# Proposed Browse to NWS Development

## Proposal Content Document

<b>Proposal title</b>	Proposed Browse to NWS Development (State component)
<b>Proponent name</b>	Woodside Energy Ltd, as Operator for and on behalf of the Browse Joint Venture
<b>Short description</b>	Drilling and completion, subsea installation, commissioning, operation, inspection, maintenance and repair and decommissioning of subsea wells and associated subsea infrastructure located in Western Australian State waters, to extract hydrocarbons from the Torosa reservoir, located approximately 425 km north of Broome and approximately 290 km off the Kimberley coast.

Figure 1 – Proposed Revised State Proposal Area (yellow) and indicative field layout.

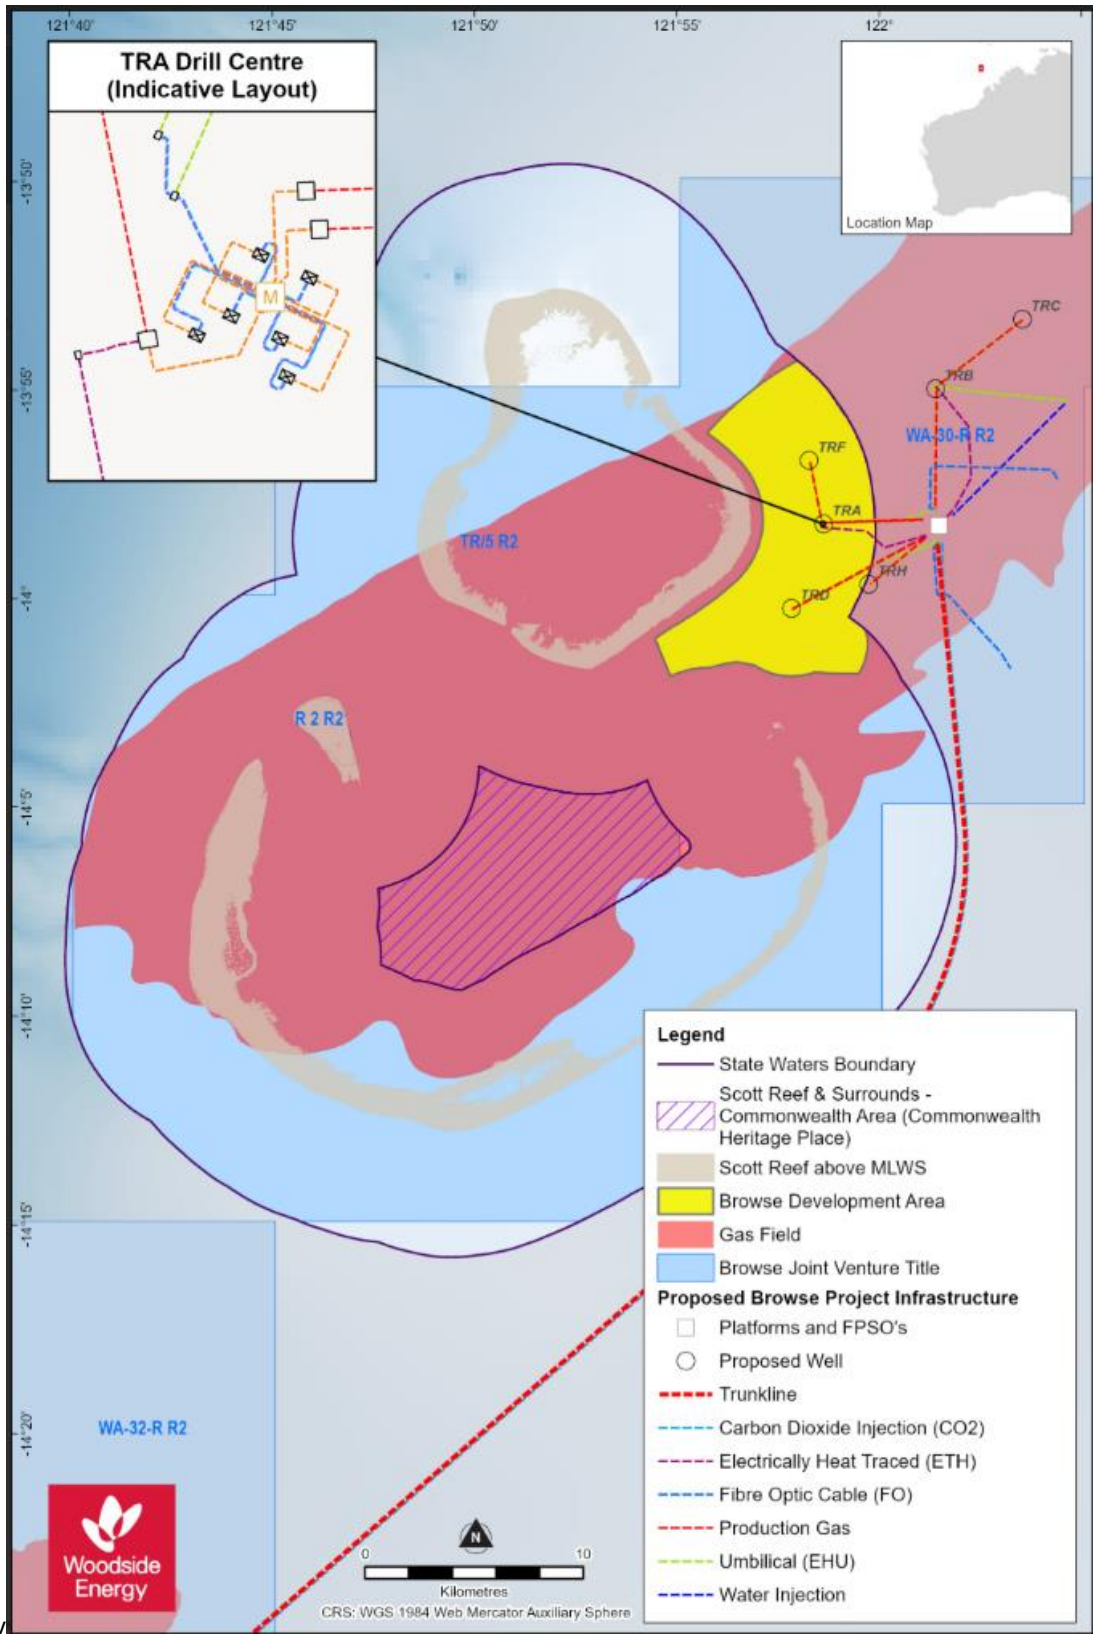
Proposal element	Location / description	Maximum extent, capacity or range (as of 12 October 2022)	Proposed Amendment	Revised extent, capacity or range
<b>Physical elements</b>				
Petroleum production wells	Installation and physical presence of infrastructure within indicative field layout as per Figure 1 below.	Up to 0.24 km <sup>2</sup> of direct seabed disturbance (including 25% contingency).  Up to 20 wells.	<p><b>Relocating one drill centre (referred to as TRD) so that and no drilling activity occurs within 20 km of Sandy Islet.</b></p> <p><b>Reduce development envelope (maximum area within which the physical elements will occur) as per Figure 2 below.</b></p>	<p>Up to 0.24 km<sup>2</sup> of direct seabed disturbance (including 25% contingency).  Up to 20 wells.</p> <p><b>No drill centre within 20 km of Sandy Islet.</b></p> <p><b>All physical elements to be installed within a Development Envelope of 78.3 km<sup>2</sup>.</b></p>

Drilling and completions operations	Drill cuttings and drilling fluids. Use of best practice technology to stop	Average of 850 m <sup>3</sup> of cuttings per well, with up to 20 wells to be developed in the	<b>Torosa Development drilling will incorporate dual pyrotechnically</b>	Average of 850 m <sup>3</sup> of cuttings per well, with up to 20 wells to be developed in the State Proposal

hydrocarbon flow to the marine in the remote likelihood a of a loss of well control event during drilling.	State Proposal Area. Up to 17,000 m <sup>3</sup> cuttings total.  Up to 130 m <sup>3</sup> of fluid discharged per well during well unloading.	<b>actuated shear rams.</b>	Area. Up to 17,000 m <sup>3</sup> cuttings total.  Up to 130 m <sup>3</sup> of fluid discharged per well during well unloading.  <b>Torosa Development drilling will incorporate dual pyrotechnically actuated shear rams.</b>
Hydrotest fluid discharges	Hydrotest fluids discharged at the seabed during integrity testing of the subsea infrastructure	One-off discharges of up to 250 m <sup>3</sup> from the TRF flowline	No change	One-off discharges of up to 250 m <sup>3</sup> from the TRF flowline
Produced water	Low volumes of water that naturally occur within the hydrocarbon bearing geological formations.	Small volumes of formation water may result during well unloading activities by the MODU. These will be directly discharged by the MODU/ I.	No change	Small volumes of formation water may result during well unloading activities by the MODU. These will be directly discharged by the MODU.

**Table 1 Updated indicative locations of Browse Drill Centres. All wells associated with each of the three drill centres will be located within 500m of this centroid.**

Centroid point	Coordinates (GDA94)	
	Longitude	Latitude
TRA	389 521 E,	8 455 338 N
TRD	387 315 E,	8 451 598 N
TRF	388 865 E,	8 458 144 N
